Traffic and Parking Peer Review Summary

Village at Cricket Lane

**55 (Rear) Pearson Drive
Newbury, Massachusetts**

**Prepared By: Stantec Consulting, Inc.
Gary Hebert, PE, Peer Reviewer**

*Sight line looking northeast from
Pearson Drive to Orchard Street*

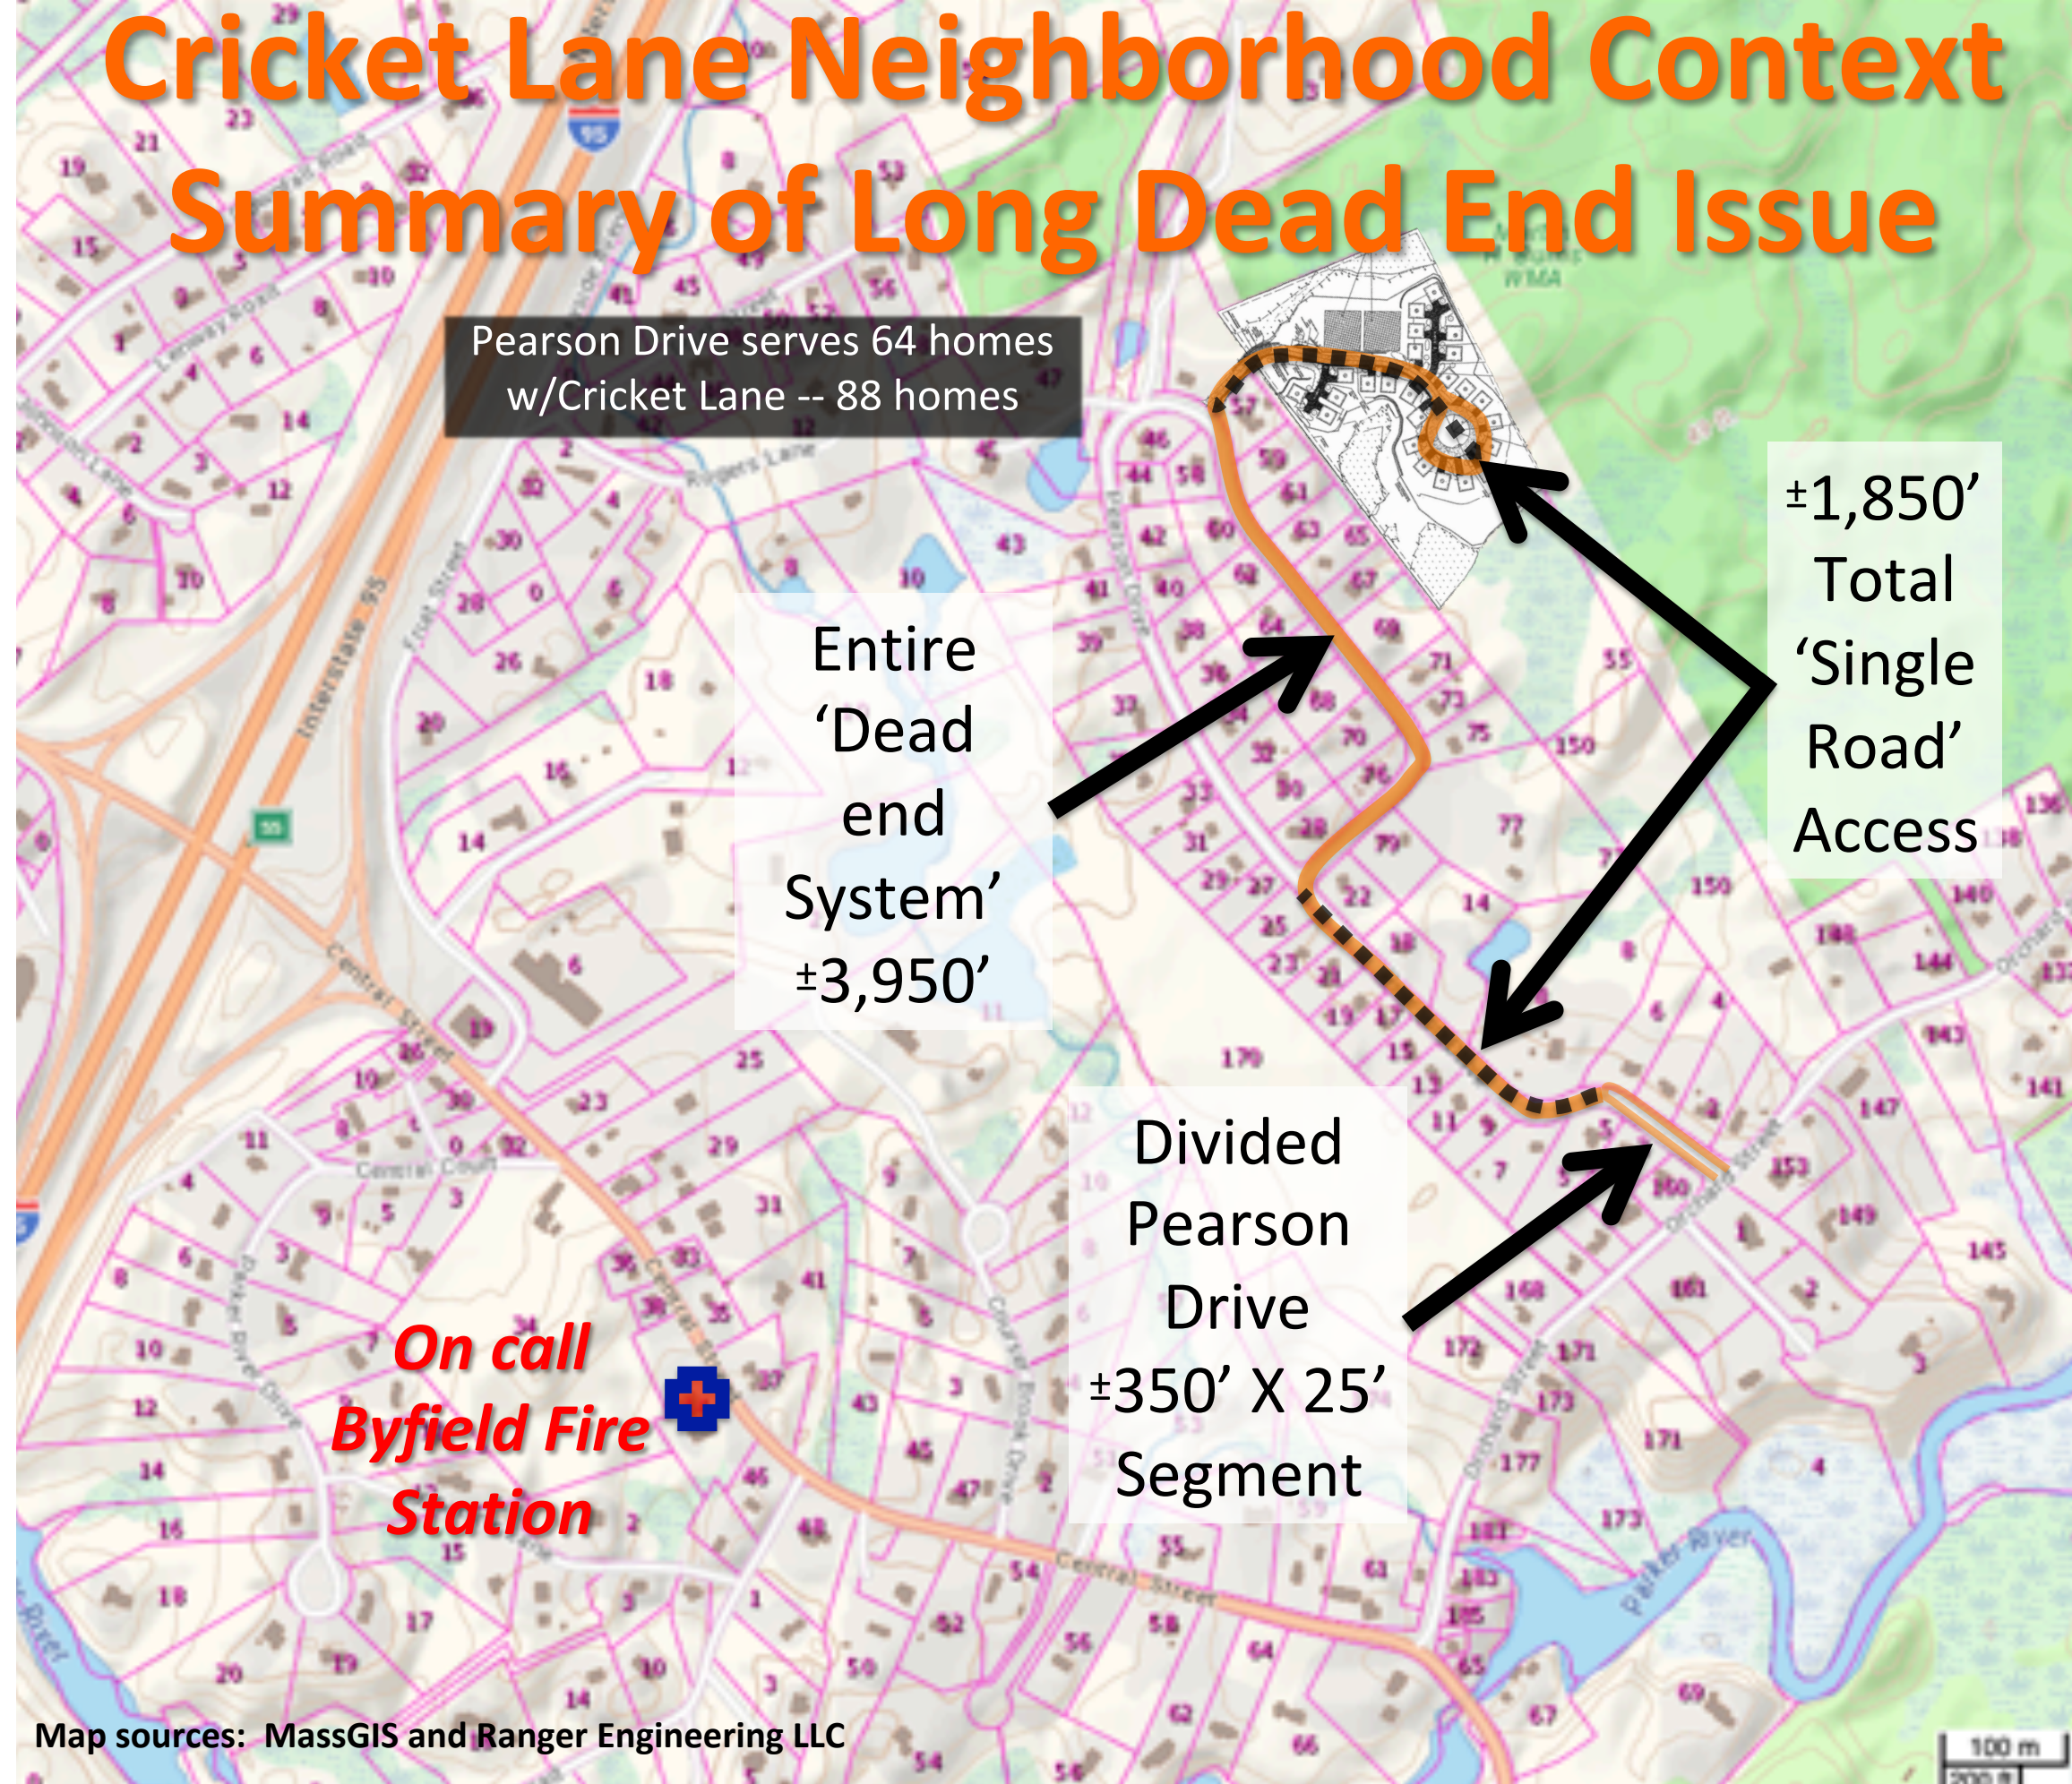
- ⦿ Sight line measurements presented in the TA report -- 700' to the north and 690' to the south for the Orchard Street at Pearson Drive intersection -- are reasonable and adequate for conditions based on observations.
- ⦿ Note: As an existing off-site intersection, even if deficient, it is not the responsibility of the Applicant to address its sight lines. The Applicant is responsible for design features of new intersections it creates.

Finding: TA sight line findings are acceptable.

Nearest Public Transportation Services

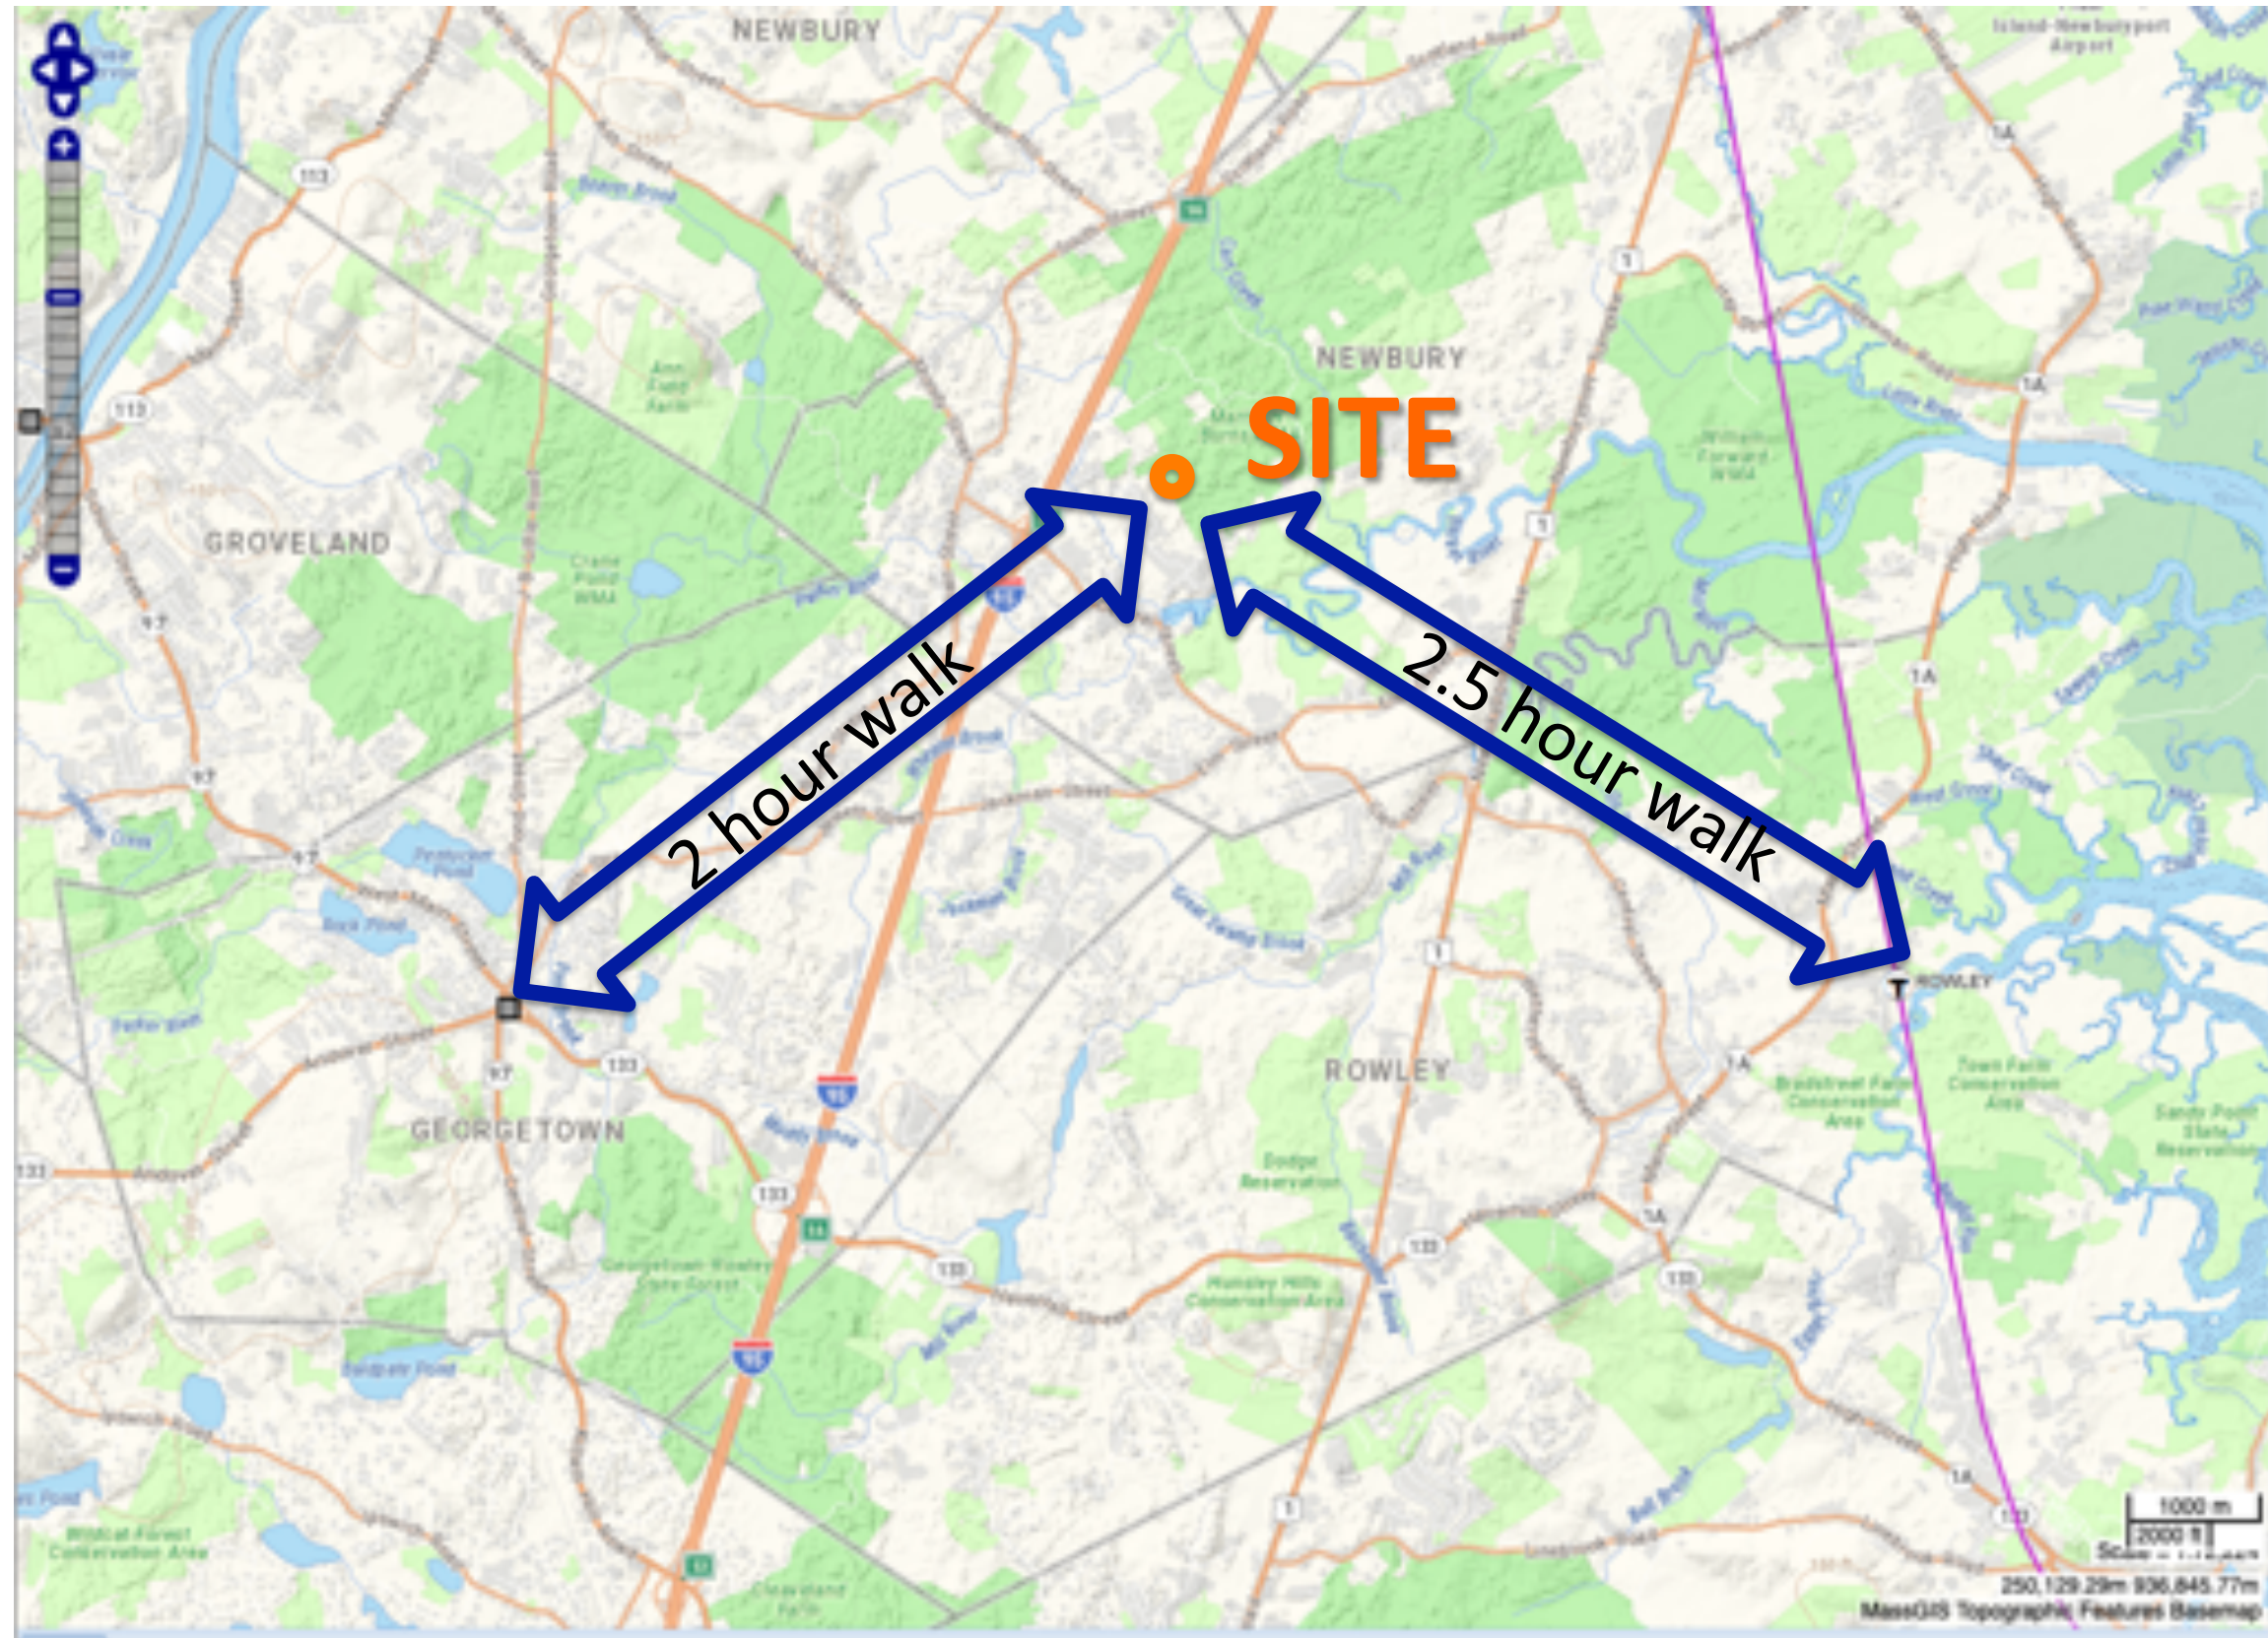
Finding: Site not convenient to public transportation

Cricket Lane Site 'Walk Score' Estimate

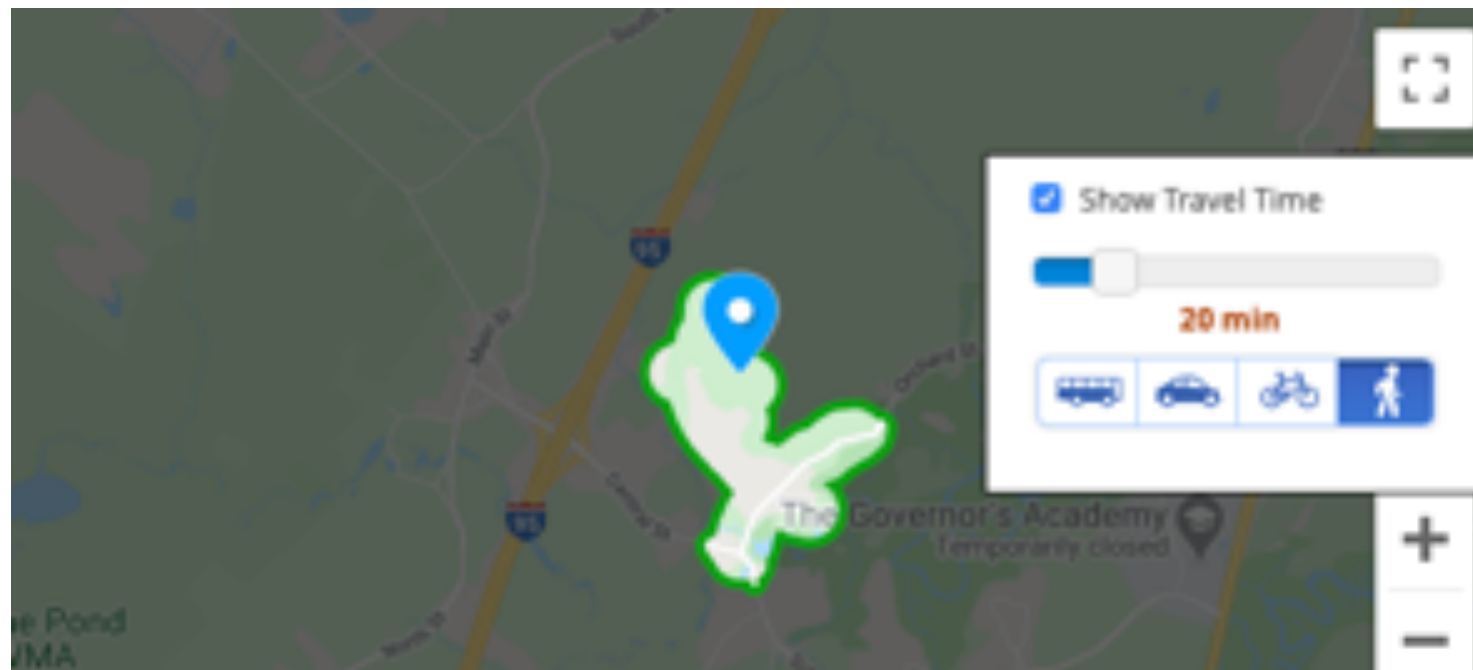
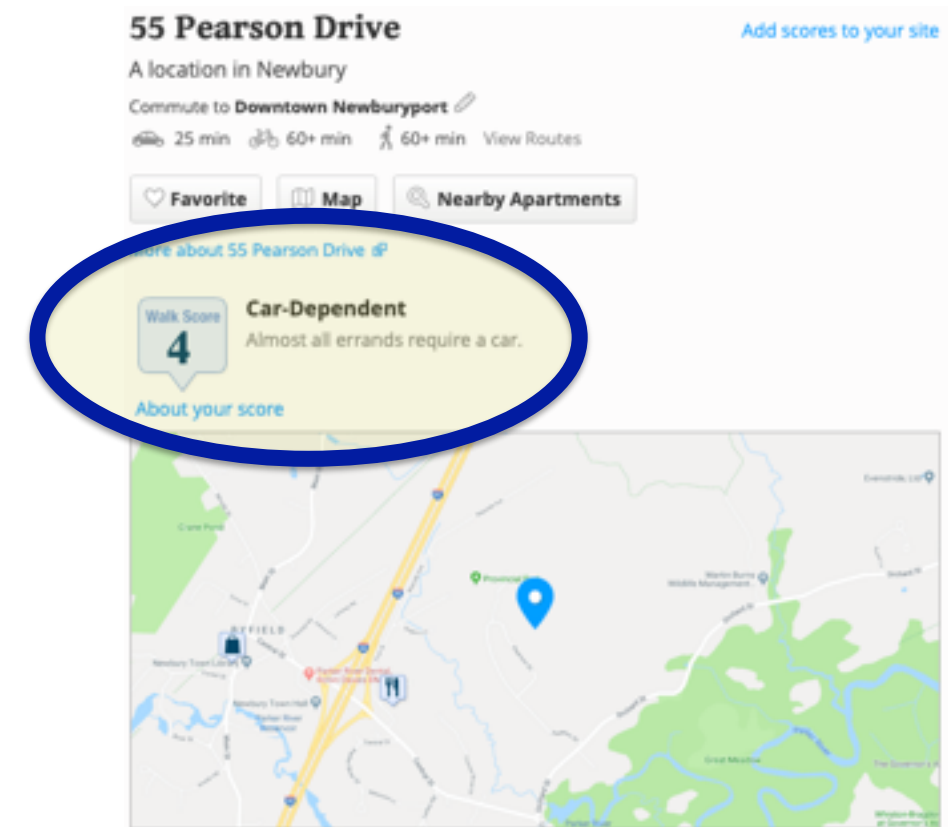
Finding: Highly auto-dependent site. Recreational walking acceptable.
